## Product Change Notice (PCN)

**Subject:** Lokreel size correction for listed Renesas ISL78365ARZ-T7A product

Appendix A – Lokreel comparison (Existing vs New)

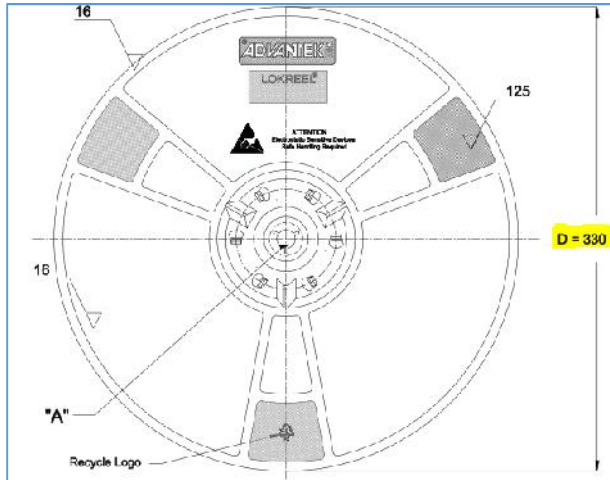
Lokreel reel size has been corrected from 13" to 7" for Renesas ISL78365ARZ-T7A tape and reel packing. There is no change to the standard pack quantity, i.e. 250 units per reel. The associated carrier tape and cover tape material as well as pocket design and dimension shall maintain per established manufacturing design.

This is a correction to the lokreel reel size only. The default ISL78365ARZ-T7A packing using 13" lokreel was in error and has been updated to use correct 7" lockreel.
